Palo Verde Nuclear
Generating Station

**SUBJECT: Palo Verde Nuclear Generating Station (PVNGS)
Units 1, 2 and 3
Docket Nos. STN 50-528/529/530
Proposed Alternative for PVNGS Units 1, 2 and 3: Use of Full-
Structural Weld Overlays in the Repair of Dissimilar Metal Welds –
Relief Request No. 36 -10 CFR 50.55a(a)(3)(i), and Request to Use a
Later Edition and Addenda of the ASME Boiler and Pressure Vessel
Code, Section XI, for Repair and Replacement Activities at PVNGS
Units 1 and 3 in accordance with 10 CFR 50.55a(g)(4)(iv)**

Relief Request No. 36

Proposed Alternative: Use of Full-Structural Weld Overlays in the Repair of Dissimilar Metal Welds

Figure 2:

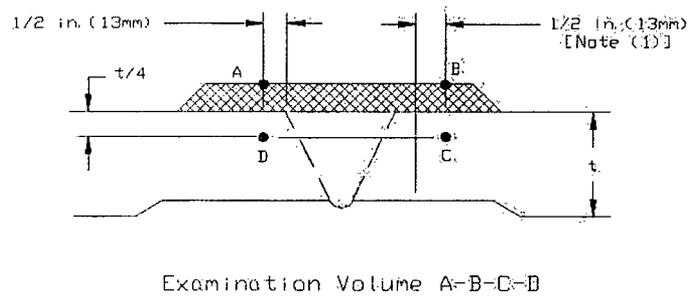
1. The examination volume A-B-C-D in Figure 2, provided below, shall be ultrasonically examined. The angle beam shall be directed perpendicular and parallel to the piping axis, with scanning performed in four directions, to locate and size any cracks that might have propagated into the upper 25% of the base material or into the weld overlay.

1. The weld overlay examination volume A-B-C-D in Figure 2 shall be added to the applicable inspection plans and shall be ultrasonically examined during the first or second refueling outage following application.

2. The weld overlay examination volume in Figure 2 shall be ultrasonically examined to determine if any new or existing cracks have propagated into the upper 25% of the base material or into the overlay. The angle beam shall be directed perpendicular and parallel to the piping axis, with scanning performed in four directions.

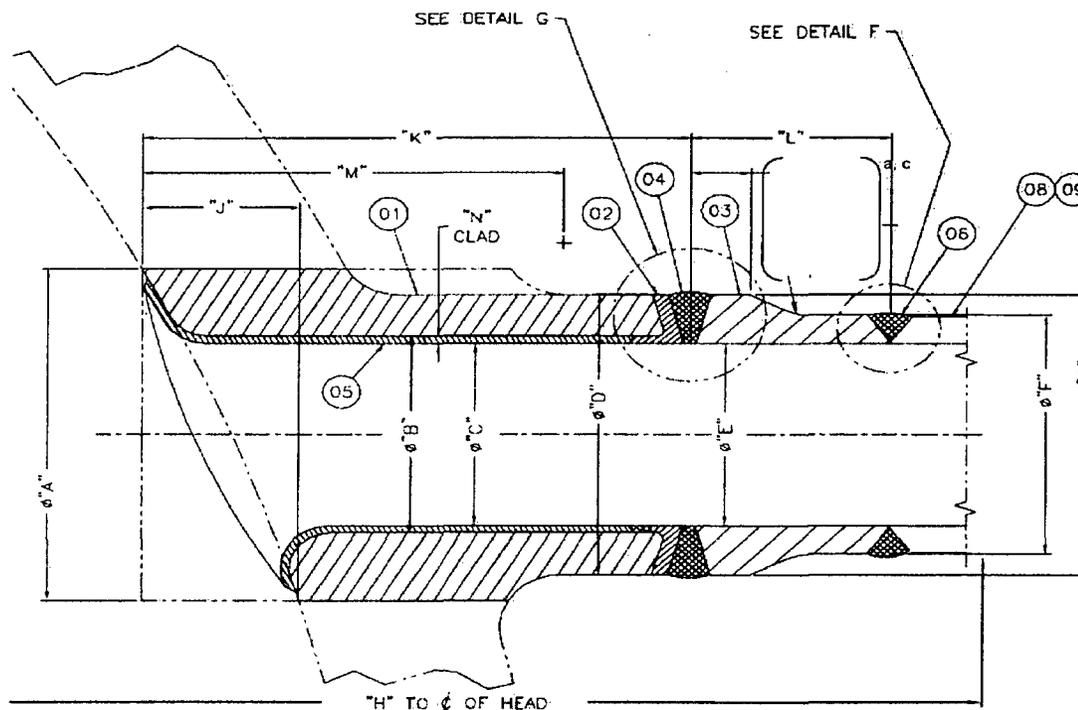
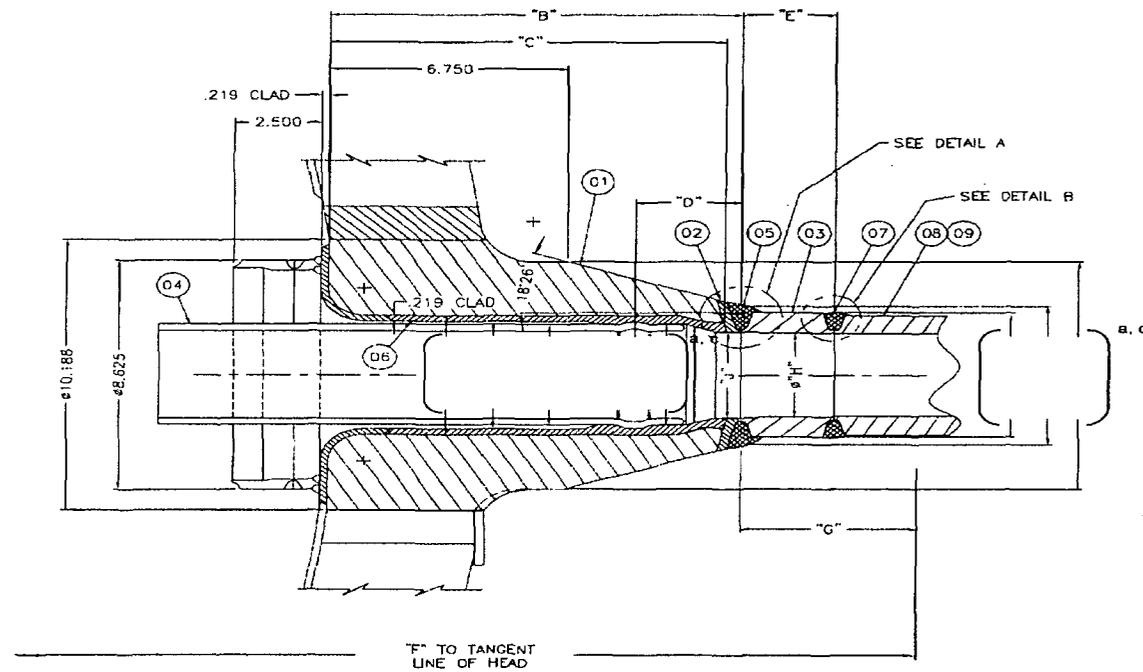
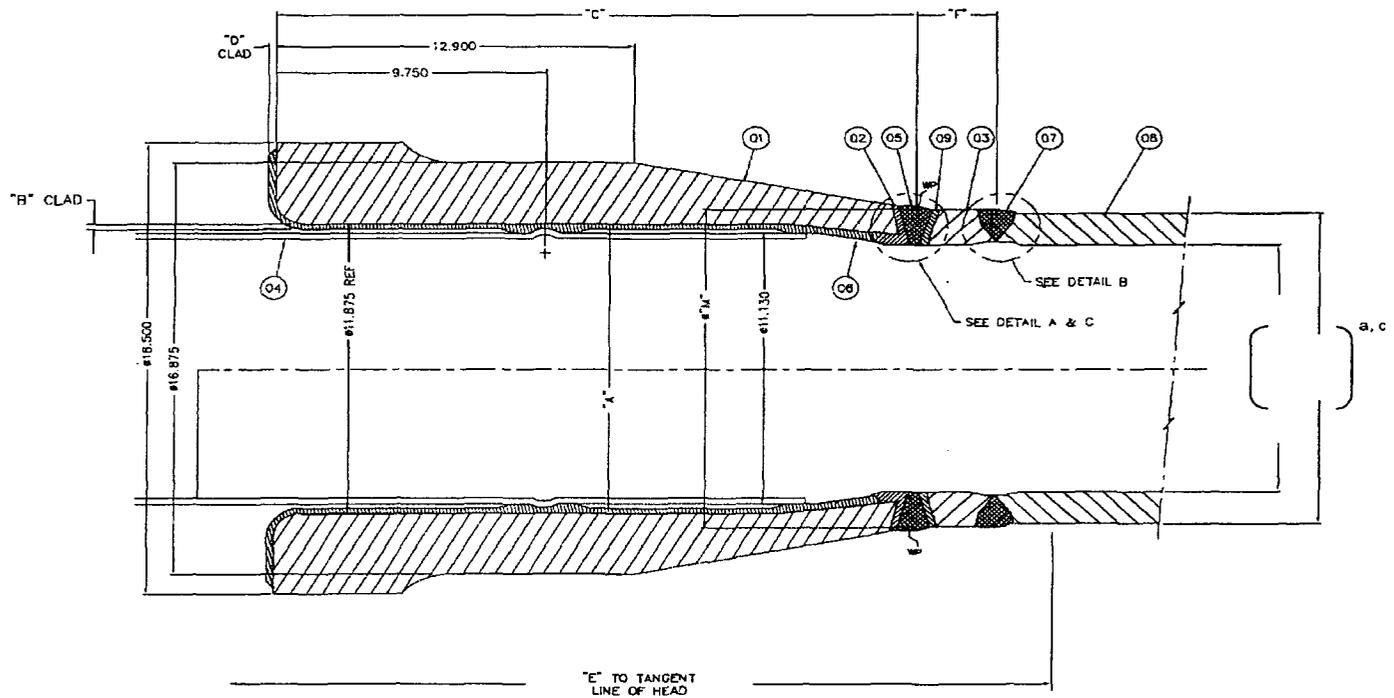
- (a) To clarify the description in Section 1(a) of the proposed alternative, provide a drawing of a typical nozzle-weld-pipe configuration including the nozzle, dissimilar metal weld, safe end, similar metal weld, pipe, and the overlay. Identify the material of each component. Provide dimensions for relief, safety, spray, and surge nozzles and piping (such as diameters and thickness) in a table. Include the thickness of weld overlays.**
- (b) Clarify when the overlay will be applied and will not be applied to the similar metal welds.**

- (a) Enclosure 2 provides typical sketches of the nozzles and the materials for each nozzle weldment. Specific dimensions and the overlay thickness are being prepared and will be in the design package available for NRC review at the plant site.**
- (b) Overlay will be applied to similar metal welds when required to satisfy dissimilar metal weld overlay design dimensions.**
